COMMENT LETTER I29 – JULIE MUMMA

The first hearing where comments and responses are provided below was before the City of Sacramento Preservation Commission on April 15th, 2015 (H1). The second hearing was before the City's Planning & Design Commission on April 30th, 2015 (H2).

Figure 2-2. Conceptual Phasing Diagram

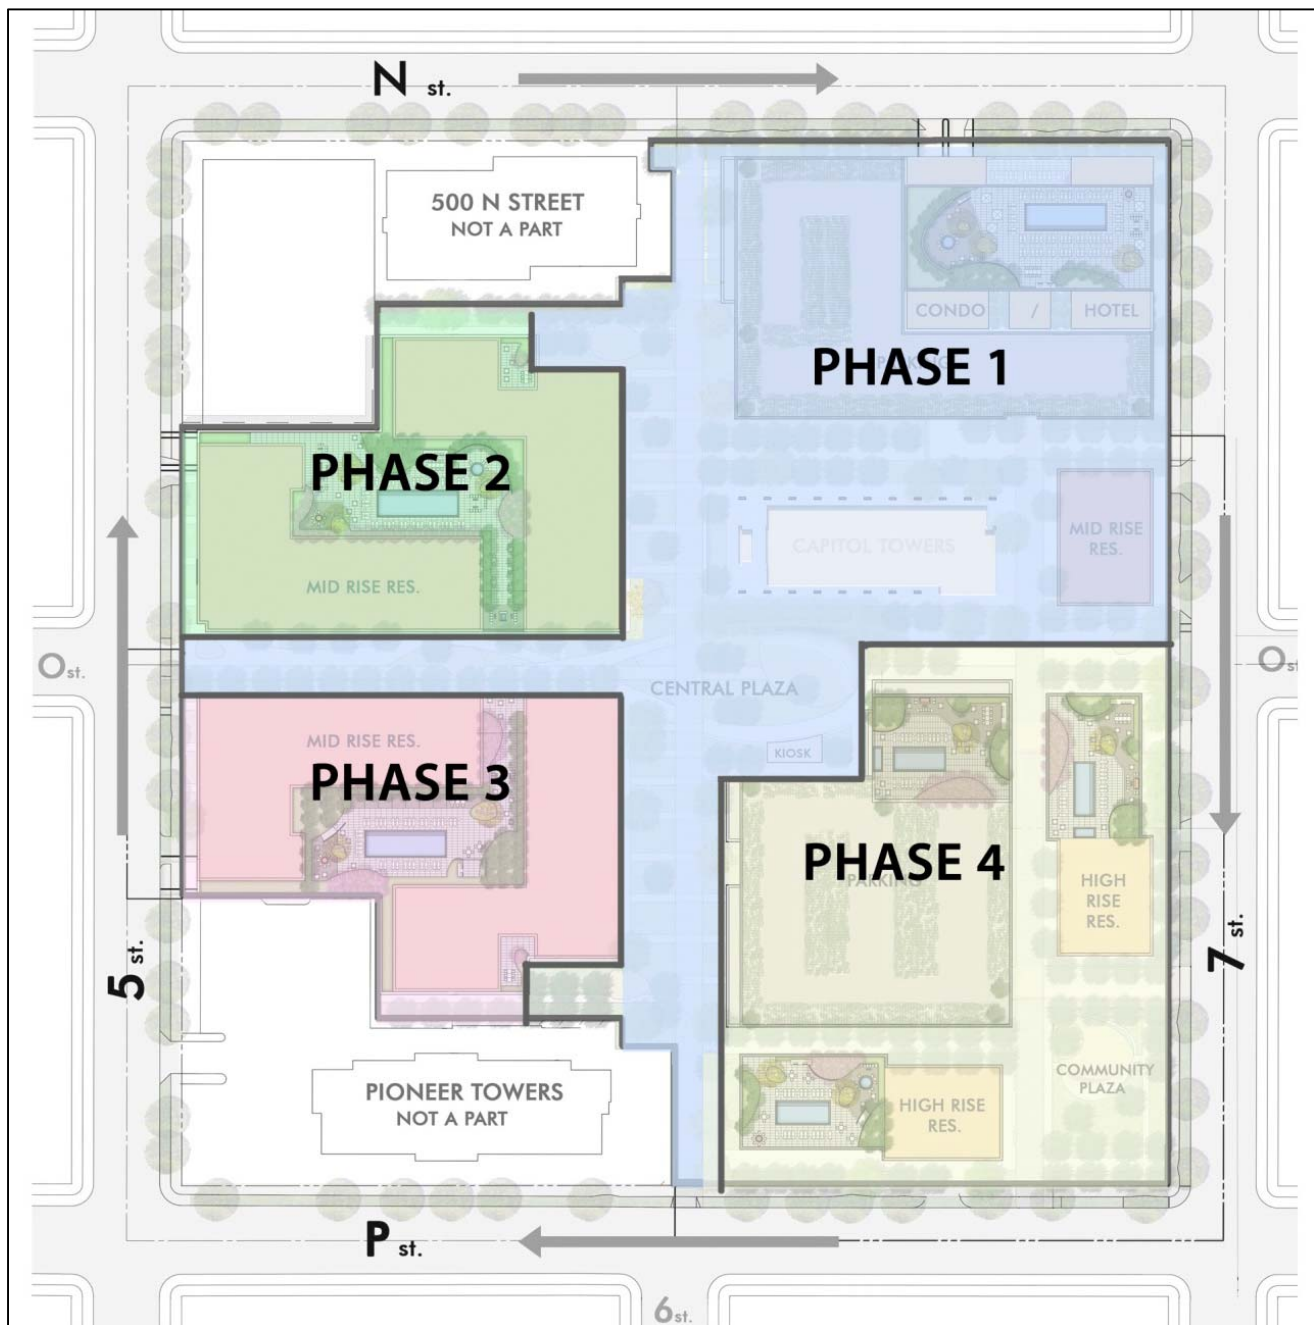
As described in detail in DEIR Chapter 2, "Project Description" (pages 2-22 through 2-24), development of Sacramento Commons is expected to occur in four phases—from late 2015 through fall 2021—to enable the project to respond to market demand (see DEIR Figure 2-6 on page 2-23). The proposed order of demolition and construction phasing may be subject to change due to market conditions. As indicated in the PUD Guidelines (DEIR Appendix N), the following measures will be implemented to ensure public access during construction activities (see PUD Guidelines Section 4.1, "Phasing," in Appendix C to this FEIR):

Residents of Bridgeway Towers, Pioneer Towers, and Capitol Towers will be notified in advance of construction or demolition activities that could affect access through the proposed project site and alternative accessways will be described for the benefit of residents. Additionally, should the City Council exercise its discretion to approve the proposed project, City staff recommends the City Council adopt a term in the development agreement requiring demolition for any phase of the proposed project not to commence until building permits have been issued for the associated construction phase.

See conceptual phasing diagram below.

Figure 2-3. New Development in Parking Areas Only

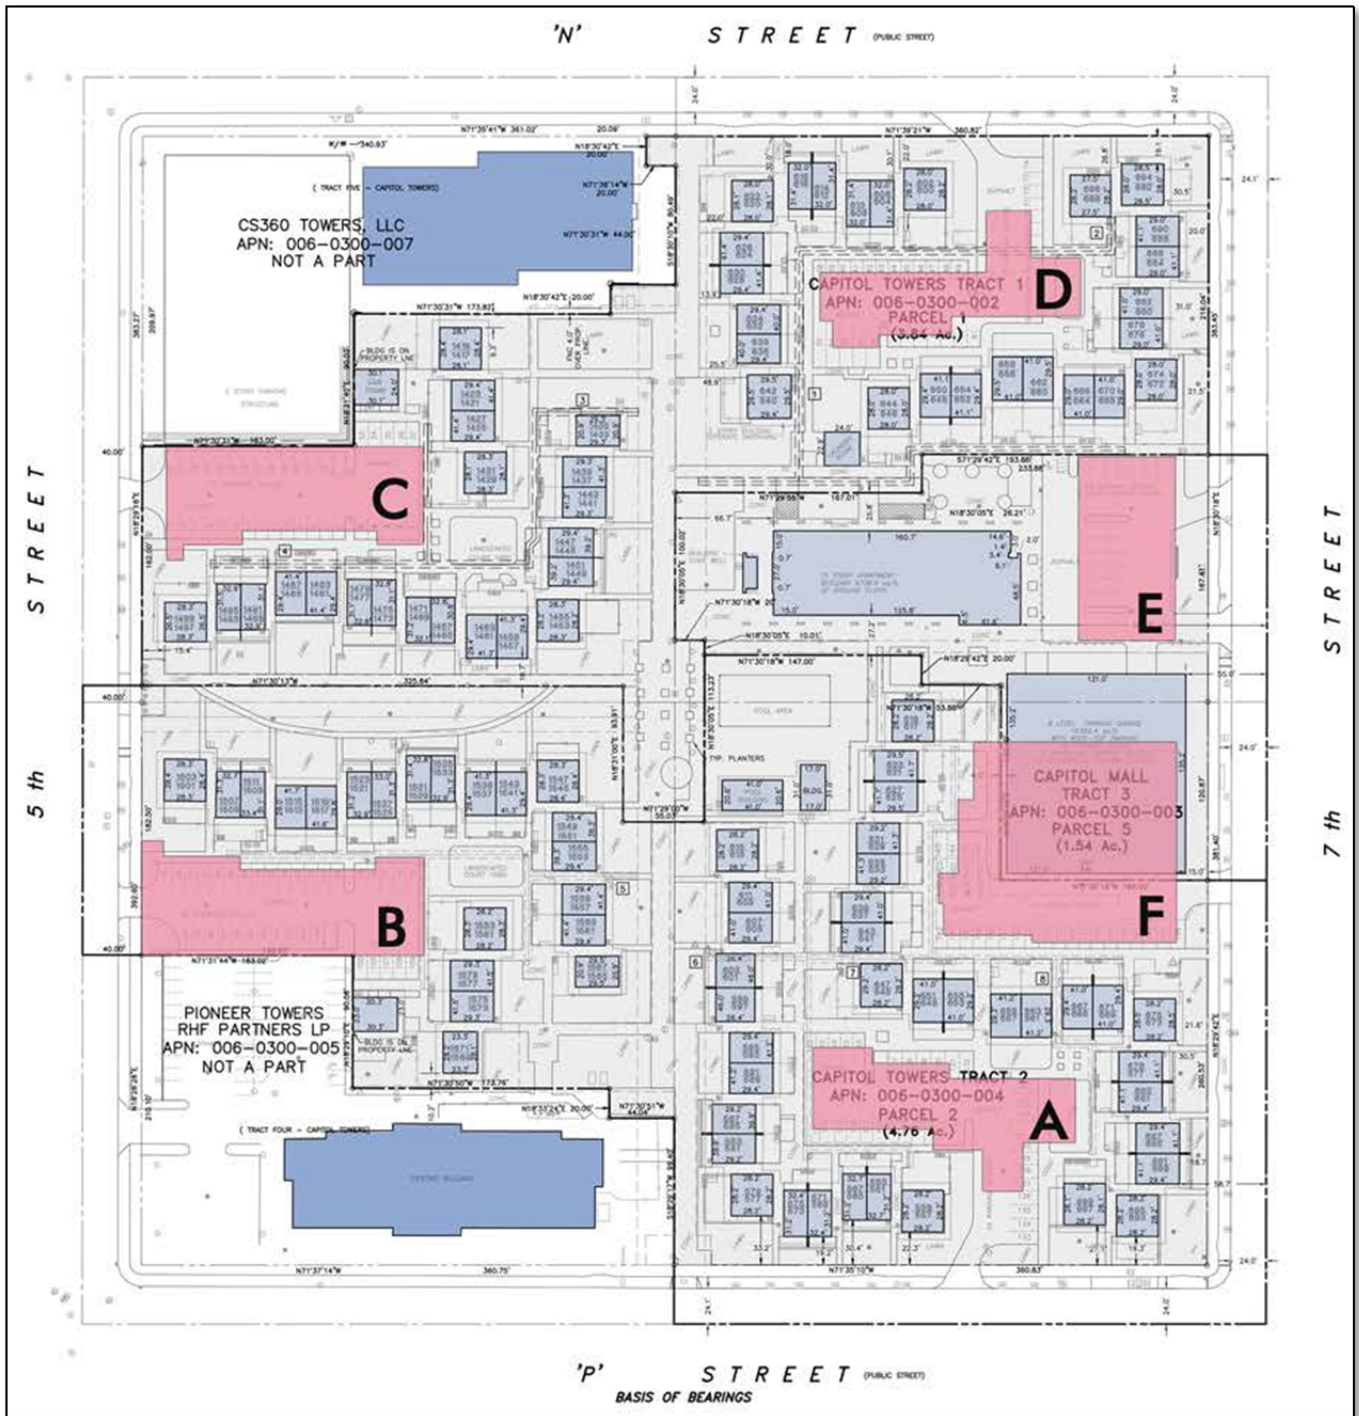
All on-site alternatives proposed by commenters reduce the density and intensity as compared to the proposed project and, therefore, are not alternatives required pursuant to CEQA. (See Master Response 2.3.9 [CEQA Streamlining].) Nevertheless, the City has considered the alternatives raised by commenters and, as discussed further below, determines that the alternatives fail to achieve basic project objectives, are inconsistent with City policies, or constitute variations of the alternatives included in the DEIR that, like the alternatives analyzed in the DEIR, are not capable of reducing the proposed project's significant and unavoidable historical resource impacts to a less than significant level.

Pursuant to the Secretary of the Interior's Standards for the Treatment of Historic Properties, the Standards for Rehabilitation may include related new construction that will not destroy historic materials, features, and spatial relationships that characterize the property. Some commenters identified a "New Development Only in Parking Areas" alternative as a potential rehabilitation alternative. Specifically, in order to permit new infill construction alongside the historic buildings and landscaping onsite, some commenters proposed an alternative in which new development would only occur within the existing parking lots on the project site and within the footprint of the existing parking structure. As explained further below this alternative poses policy issues from a City policy perspective and would not be able to accommodate the density included in the proposed project.

The “new development only in parking areas” alternative allows for development within the areas shown in Figure 2-3.

Figure 2-6. On-Site Easements

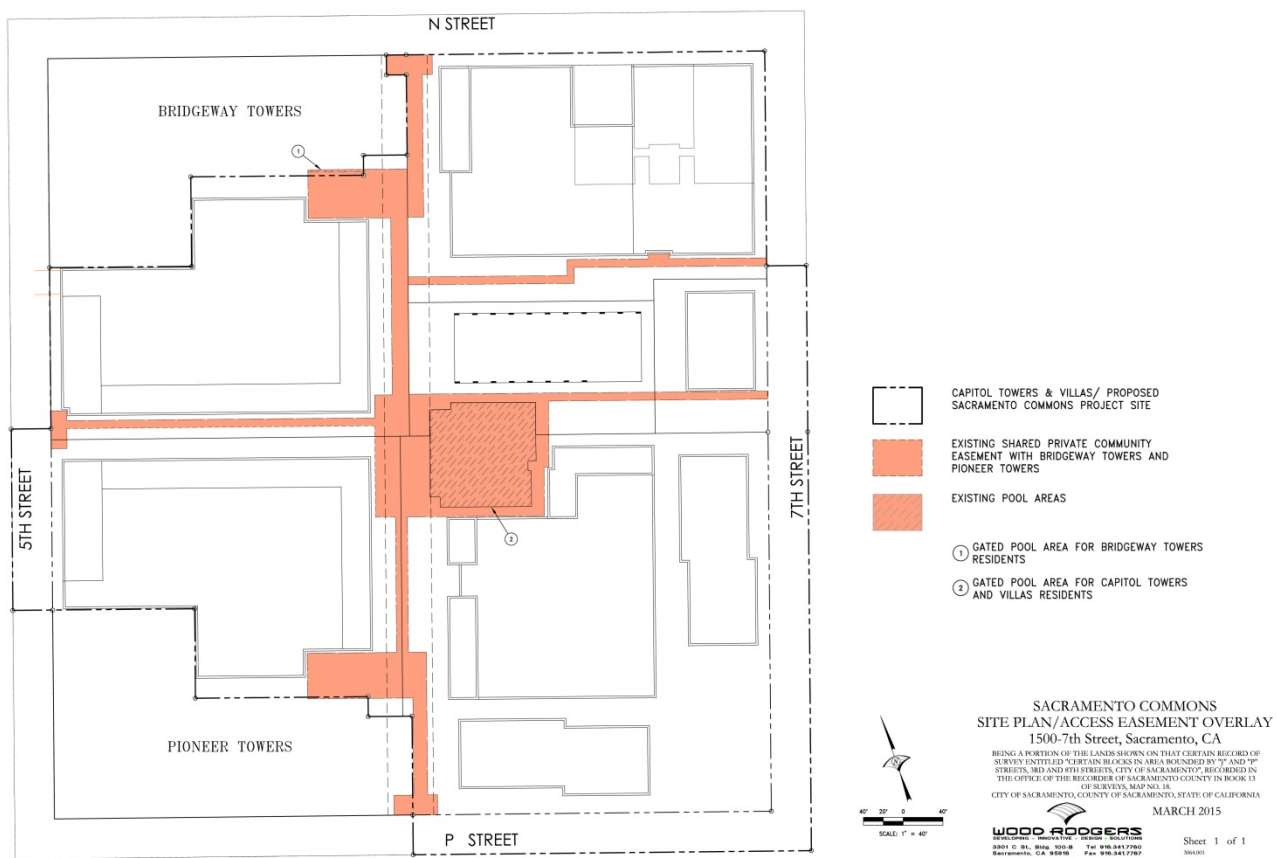
Some commenters identify the presence of on-site easements and ask about their continued use following development of the proposed project. Some private community easements remain on the project site, as identified in the attached figure (Figure 2-6). The private community easements grant the Pioneer Towers property and the 500 N Street (also known as Bridgeway Towers) property use of the easement areas identified in the exhibit below for right-of-way and recreational purposes. As shown, the private community easements are located within the East-West Promenade, North-South Promenade, and other pedestrian pathways included as a part of the proposed project.

The existence of private community easements does not have any bearing on the evaluation of the potential significance of park and recreation impacts caused by the proposed project. The grant
